Access Compliance Report

Public Rights-of-Way

Intersection ID: 47035	Main Street: W_ARROWWOOD_RD	Cross Street: STONEGROVE_LN	Location: SE
ADA ID: 19E9E93675D6	Ramp Type: Perp	Initial Pass/Fail: Fail	Overall Compliance: No
		Severity Score: 12.5

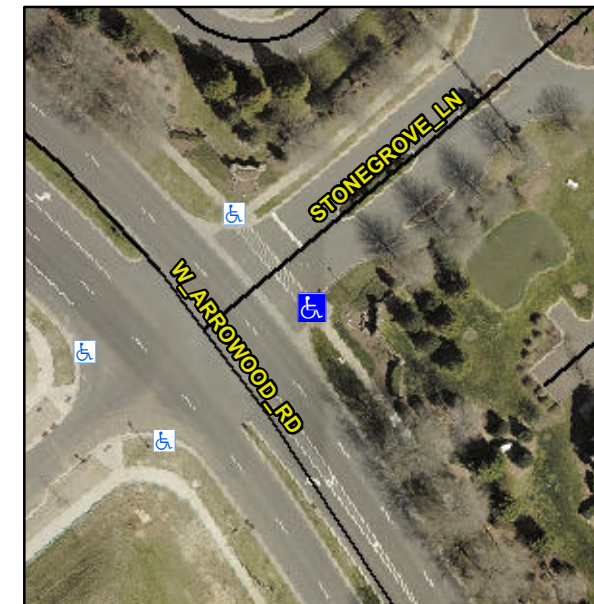
Not Found, R304.5.3

Compliance	Description	Data	Compliance	Description	Data
N/A	Ramp Length (in)	53.5	Yes	Ramp Slope (%)	5.1
Yes	Ramp Width (in)	49.0	No	Ramp XSlope (%)	6.5
N/A	Flare Type LT	N/A	N/A	Flare Type RT	N/A
N/A	Flare Slope LT (%)	N/A	N/A	Flare Slope RT (%)	N/A
N/A	Flare Traversable LT?	N/A	N/A	Flare Traversable RT?	N/A
N/A	Landing Length (in)	N/A	N/A	DWS Provided?	N/A
N/A	Landing Width (in)	N/A	N/A	DWS Contrast?	N/A
N/A	Landing Slope (%)	N/A	N/A	DWS Length (in)	N/A
N/A	Landing X Slope (%)	N/A	N/A	DWS Full Width?	N/A
N/A	Landing Curb? (Y/N)	N/A	N/A	DWS Offset (in)	N/A
N/A	Shared Landing?	N/A			
N/A	Gutter Ponding?	N/A	N/A	Gutter Slope (%)	N/A
N/A	Gutter Lip Ht (in)	N/A	N/A	Gutter X Slope (%)	N/A
N/A	Painted X Walk1?	Yes	N/A	Painted X Walk2?	N/A
	X Walk 1 Direction	To NW		X Walk 2 Direction	N/A
N/A	X Walk 1 Width (in)	68.0	N/A	X Walk 2 Width (in)	N/A
	X Walk 1 Slope (%)	0.4		X Walk 2 Slope (%)	N/A
	X Walk 1 X Slope (%)	6.3		X Walk 2 X Slope (%)	N/A

Remove & Replace Entire Ramp.
